**STATE OF NEW YORK**  
**COMMUNITY DEVELOPMENT BLOCK GRANT**  
**DISASTER RECOVERY (CDBG-DR) PROGRAM**  
**SUBSTANTIAL AMENDMENT NO. 21**

**Activity Name:** Tottenville Shoreline Protection Project (TSPP)

## **Public Comments**

**Figure 1: Shoreline Risk Reduction Measures**

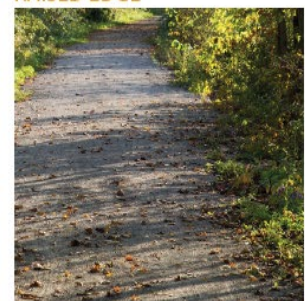
The State received comments stating that the pathway segment (revetment and trail) of the project will cause flooding on the landward side because water will be trapped behind the revetment.

The State received comments stating that the pathway segment (revetment and trail) will lead to crime and endanger nearby property owners.

The State received comments stating that the pathway segment (revetment and trail) will encroach on natural habitat.

The State received comments stating that the pathway segment (revetment and trail) does not provide protection to the shoreline and is not a valid expenditure of disaster recovery funds.

The State received a comment expressing concern that the project was being redesigned to reduce protection for the area southwest of Brighton Street.

The State received a comment stating that the project will remove the wetland area and replace it with an eco-revetment.

See Chapter 24 of the FEIS, particularly Comment 68 (page 24-45), Comment 74 (page 24-48), and Comment 150 (page 24-84), regarding the porous nature of the treatments and the purposeful design which will allow water to seep through.

See Chapter 24 of the FEIS, particularly Comment 76 (pages 24-48 to 24-52) regarding the location of the trail completely within the public property of the New York City Departments of Parks and of Transportation. Furthermore, consultation has occurred with the NYPD regarding this area.

See Chapter 24 of the FEIS, particularly Comment 113 (page 24-70), Comment 120-121 (pages 24-72 to 24-73), and FEIS Appendix B ([https://stormrecovery.ny.gov/sites/default/files/crp/community/documents/Appendix%200B\\_Coastal%20Management%20Program%20Assessment.pdf](https://stormrecovery.ny.gov/sites/default/files/crp/community/documents/Appendix%200B_Coastal%20Management%20Program%20Assessment.pdf)), all of which describe the analyses and consultations undertaken to ensure that the project will not have a negative effect on the environment.

See Chapter 24 of the FEIS, particularly Comment 3 (pages 24-4 to 24-5) and Comment 76 (pages 24-48 to 24-52) which explain the purpose and need of this section of the project to control erosion and to provide physical and visual access to the water's edge.

The current design of the project has the westernmost point of the earthen berm beginning at Billop Avenue, just west of Swinnerton St., somewhat shortening the berm from the preliminary design. The initial coastal modeling indicated that this design would not

detract from the Project's ability to meet its resiliency goals. As the design process continues, additional coastal modeling will be undertaken to confirm this determination.

See Chapter 24 of the FEIS, particularly Comment 104 (pages 62-63), which explains how the eco-revetment will be designed to minimize impacts on the wetland. Furthermore, any remaining impacts on the wetland will be mitigated by either the purchase of mitigation credits or physical mitigation of a nearby wetland.
